Accessibility Survey

5th Street & Brookshire Avenue

Date of Inspection 4/18/2017

Prepared By **Disability Access Consultants**(800) 743-7067

Change in Level East of Brookshire Avenue @ 33.941593172110, -118.125286996365

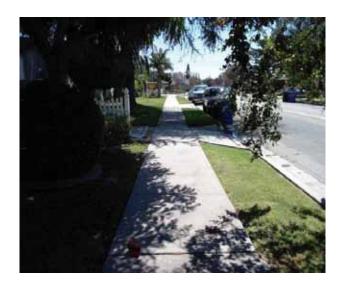
There is a change in elevation greater than recommended value.

On-Site Finding 0.50 inches

Ensure that the change in elevation is within the recommended value.

Change in Level East of Tristan Drive @ 33.940266954588, -118.122987002134

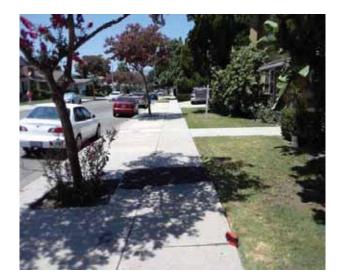
There is a change in elevation greater than recommended value.

On-Site Finding 0.62 inches

Ensure that the change in elevation is within the recommended value.

Change in Level West of Lakewood Boulevard @ 33.939833036652, - 118.122795224190

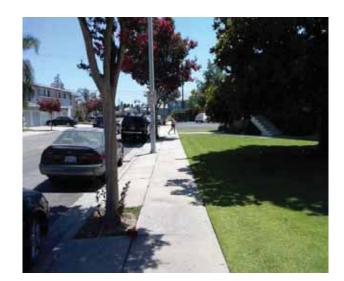
There is a change in elevation greater than recommended value.

On-Site Finding 0.75 inches

Ensure that the change in elevation is within the recommended value.

Change in Level West of Lakewood Boulevard @ 33.939833036652, - 118.122795224190

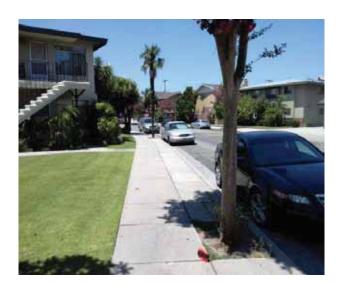
There is a change in elevation greater than recommended value.

On-Site Finding 0.75 inches

Ensure that the change in elevation is within the recommended value.

Change in Level West of Lakewood Boulevard @ 33.940734248354, - 118.124220818281

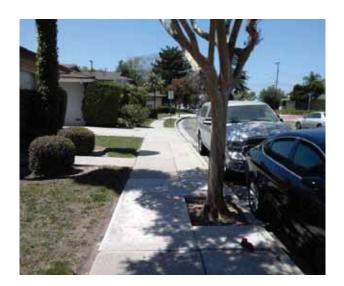
There is a change in elevation greater than recommended value.

On-Site Finding 1.12 inches

Ensure that the change in elevation is within the recommended value.

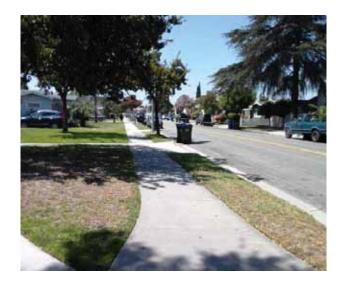
Sidewalk cross slope is not compliant.

On-Site Finding 3.30 percent for 57.00 feet

Repave the sidewalk surface with the recommended cross slope.

Change in Level West of Brookshire Avenue @ 33.942339716677, - 118.127147108316

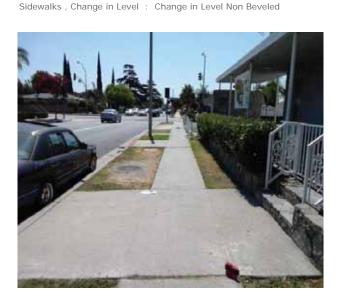
There is a change in elevation greater than recommended value.

On-Site Finding 0.62 inches

Ensure that the change in elevation is within the recommended value.

Change in Level East of Dolan Avenue @ 33.942660139163, -118.127415329218

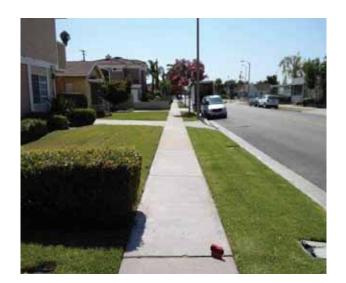
There is a change in elevation greater than recommended value.

On-Site Finding 0.37 inches

Ensure that the change in elevation is within the recommended value.

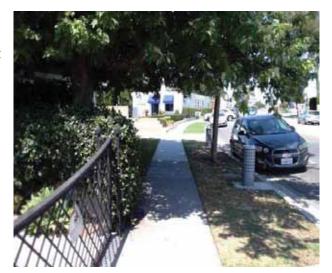
Sidewalk cross slope is not compliant.

On-Site Finding 3.60 percent for 228.00 feet

Repave the sidewalk surface with the recommended cross slope.

Change in Level West of La Reina Avenue @ 33.945381456515, -118.133671581745

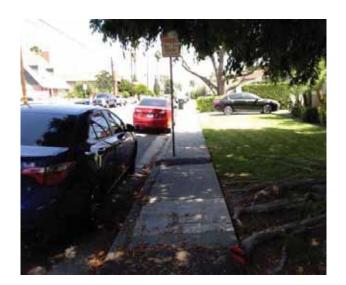
There is a change in elevation greater than recommended value.

On-Site Finding 1.50 inches

Ensure that the change in elevation is within the recommended value.

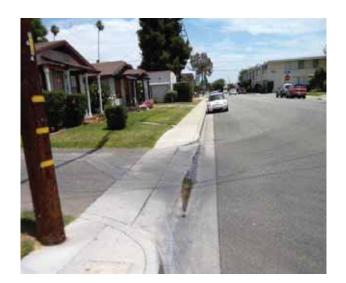
On-Site Finding Not Found

Provide detectable warnings.

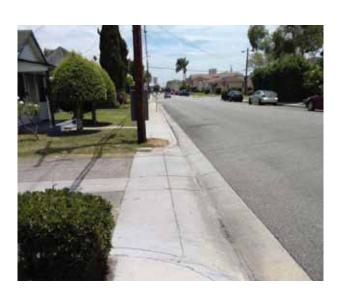
There are no detectable warnings where the pedestrian route crosses vehicular traffic.

On-Site Finding Not Found

Provide detectable warnings.

Change in Level East of Smallwood Avenue @ 33.946917860961, -118.135676532984

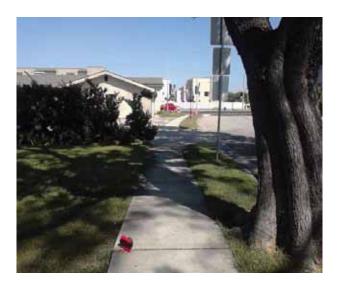
There is a change in elevation greater than recommended value.

On-Site Finding 0.62 inches

Ensure that the change in elevation is within the recommended value.

Change in Level East of Smallwood Avenue @ 33.947167065151, -118.136190176010

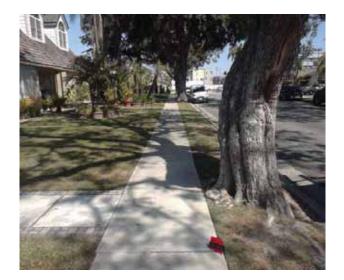
There is a change in elevation greater than recommended value.

On-Site Finding 0.62 inches

Ensure that the change in elevation is within the recommended value.

Change in Level East of Smallwood Avenue @ 33.947349517756, -118.136534839869

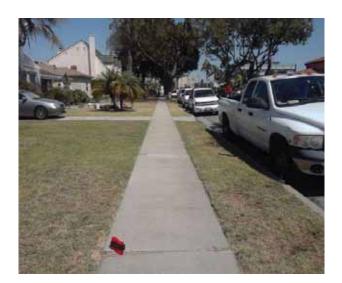
There is a change in elevation greater than recommended value.

On-Site Finding 0.87 inches

Ensure that the change in elevation is within the recommended value.

Change in Level West of Paramount Boulevard @ 33.946979049557, - 118.136135190725

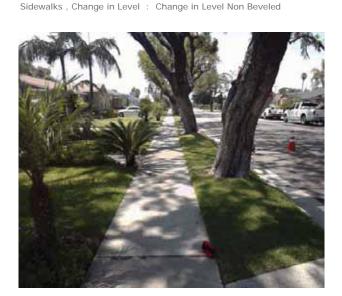
There is a change in elevation greater than recommended value.

On-Site Finding 0.62 inches

Ensure that the change in elevation is within the recommended value.

Change in Level West of Paramount Boulevard @ 33.947355080329, - 118.136906325817

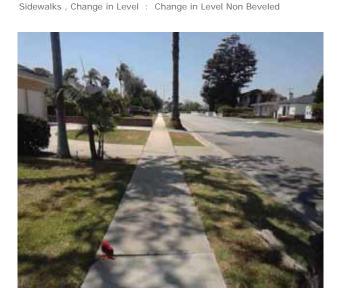
There is a change in elevation greater than recommended value.

On-Site Finding 1.25 inches

Ensure that the change in elevation is within the recommended value.

Change in Level West of Paramount Boulevard @ 33.947380668161, - 118.136934489012

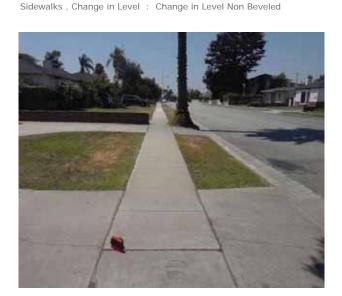
There is a change in elevation greater than recommended value.

On-Site Finding 0.50 inches

Ensure that the change in elevation is within the recommended value.

Change in Level West of Smallwood Avenue @ 33.947964736156, - 118.138079792261

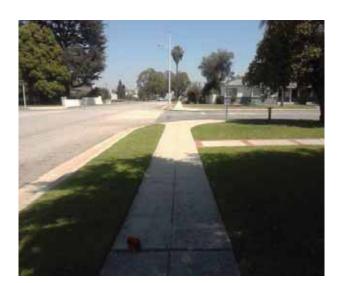
There is a change in elevation greater than recommended value.

On-Site Finding 0.50 inches

Ensure that the change in elevation is within the recommended value.

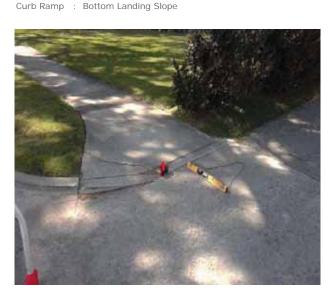
The bottom landing of the curb ramp is on the street, and the slope of the bottom landing is not compliant.

On-Site Finding 6.00 percent

Ensure the bottom landing slope is compliant and provides a smooth transition.

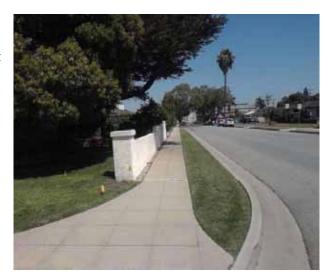
Sidewalk cross slope is not compliant.

On-Site Finding 3.60 percent for 285.00 feet

Repave the sidewalk surface with the recommended cross slope.

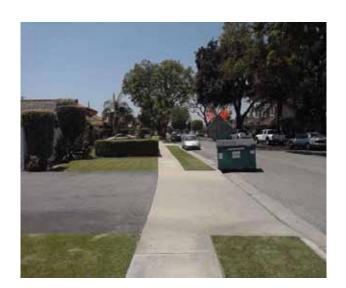
On-Site Finding Not Found

Provide detectable warnings.

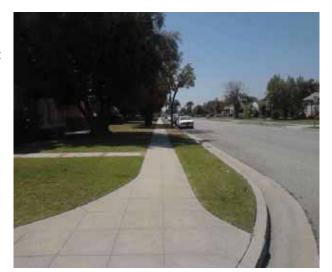
Sidewalk cross slope is not compliant.

On-Site Finding 4.60 percent for 483.00 feet

Repave the sidewalk surface with the recommended cross slope.
